**Our Case Number: ABP-317660-23**

**Re:** Busconnects Kimmage to city centre core bus corridor scheme  
Kimmage, Dublin

Please see attached Submission from Dublin City Council Chief Executive to An Bord Pleanála in relation to the National Transport Authority's BusConnects Dublin Kimmage to City Centre Core Bus Corridor Scheme.

Figure 4. Plan of the proposed boardwalk. Note lack of features highlighting the watercourse or monument beneath.

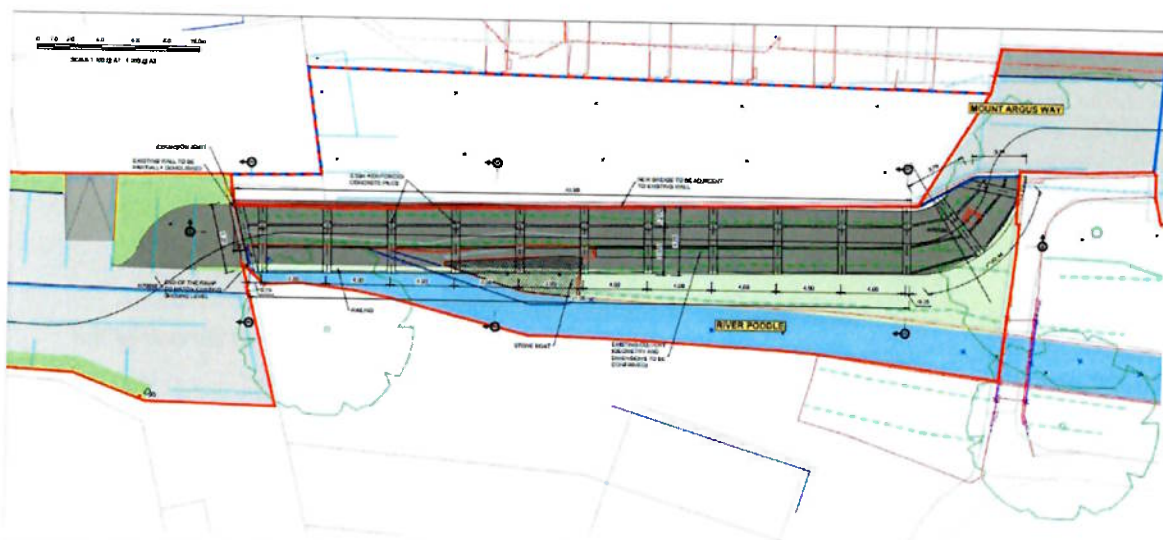
The currently designed boardwalk runs over the top of the Tongue. It is stated that *“The boardwalk deck will be perforated such that the Stone Boat will be visible through it”* however it is not clear from the supplied drawings and photomontage images that this will be the case. No photomontage is presented showing the view of the Tongue from the boardwalk. As presented, there is a uniform *“perforated metal deck with slip resistance”*. No attempt is made in the deck design to distinguish the area above the monument and the water courses. It is likely, therefore, that the effect will be to obscure the monument. It is submitted that consideration should be given to a redesign of the deck to highlight the Tongue, perhaps including glass or similar transparent panels directly above it to ensure visibility.

Figure 5. Plan of the boardwalk with line of the water channels indicated in blue and the area of the Tongue highlighted in white. Consideration should be given to marking these in the boardwalk design through glass panels or differential decking material.

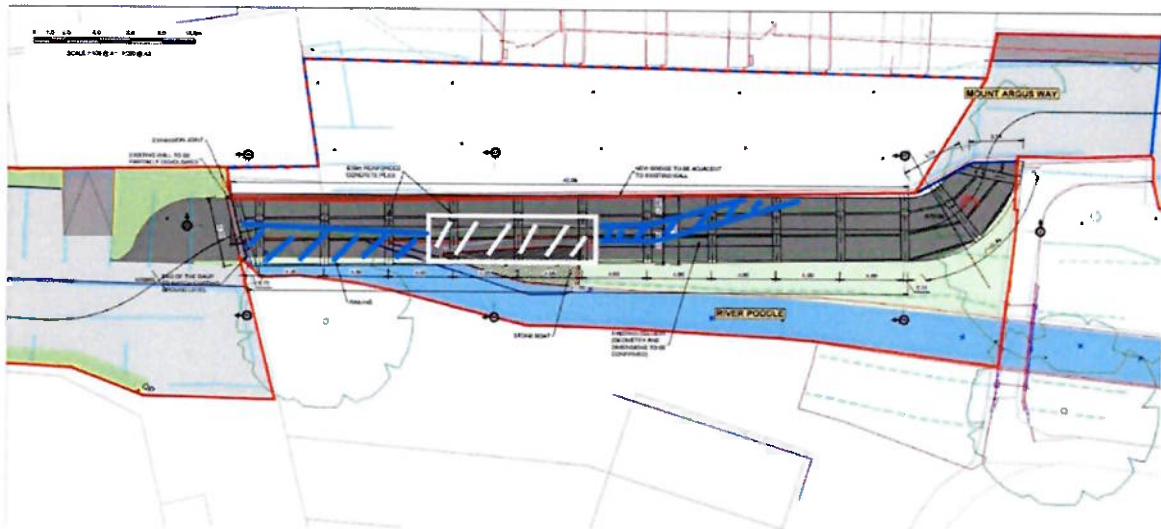
It is also stated that information panels will be installed. Two are shown on the provided drawings. No details of design or content are provided however. These should be carefully designed and written, providing information not just on the immediate monument, but also allowing the viewer to situate it in its wider context of the River Poddle and the city's water supply. Local groups have recently been in touch with the DCC Heritage Officer separately from the current Bus Connects proposal seeking to get interpretive signage installed at this location. Ideally, the information panels should be designed in conjunction with DCC and with input from local heritage groups.

Figure 6. Potential shorter boardwalk design, allowing unobstructed viewing of the Tongue and the spilt watercourse. This would require cycle route to run through Mount Argus Square and removal of parking on street.

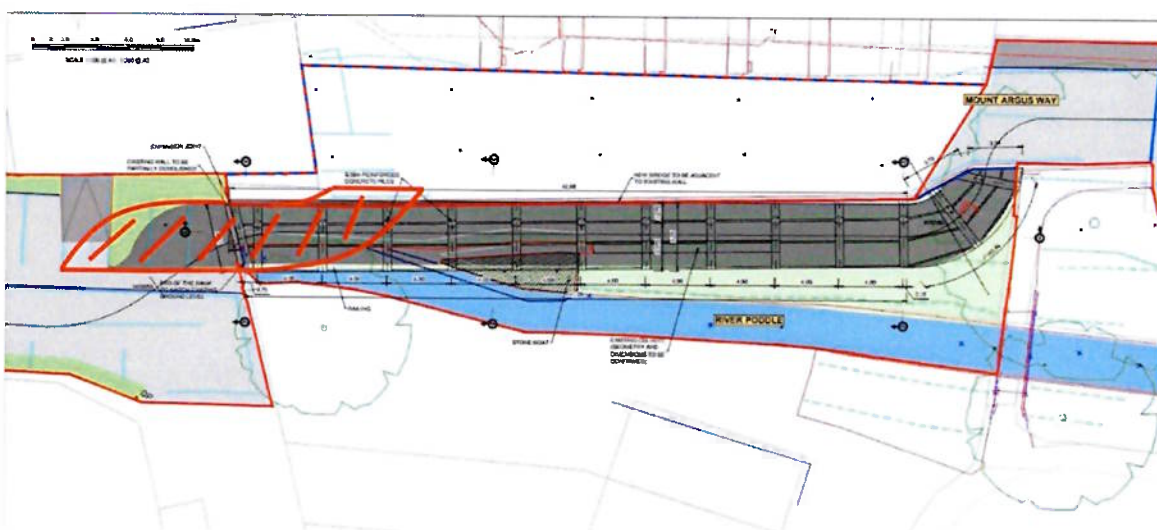
Finally, it is not clear if any alternate designs for the boardwalk were considered. A shorter boardwalk not running over the top of the monument appears to be possible, although this would require running the cycle route through Mount Argus Square.

Sheet 3:

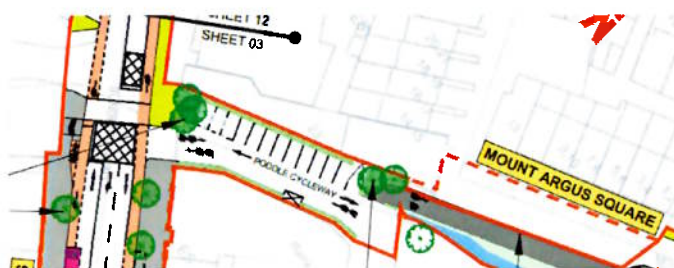
Replace Prunus species with longer life tree species.

The potential to daylight the short section of the Poddle River should be an objective rather than retaining car parking at the 'Poddle Cycleway' area, below:

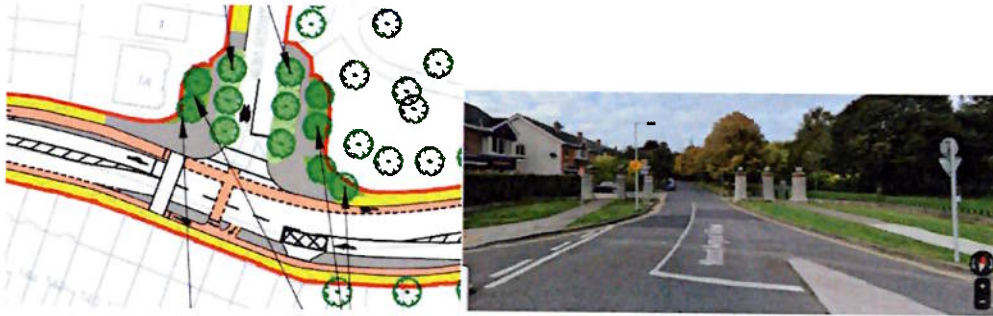
Proposals of tree planting on existing river culvert should be reviewed.

Sheet 9:

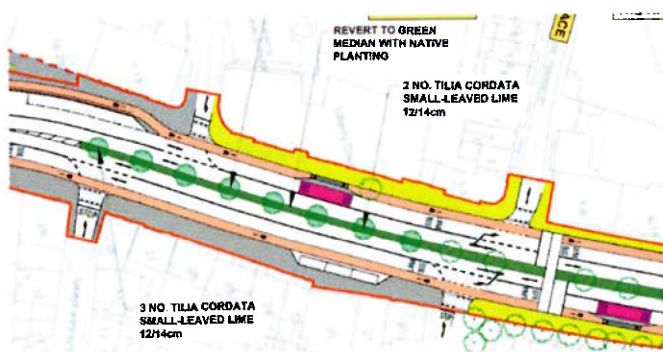
The proposed central median planting is welcomed. Please review species varieties for compact canopy forms due to traffic flow on both sides.
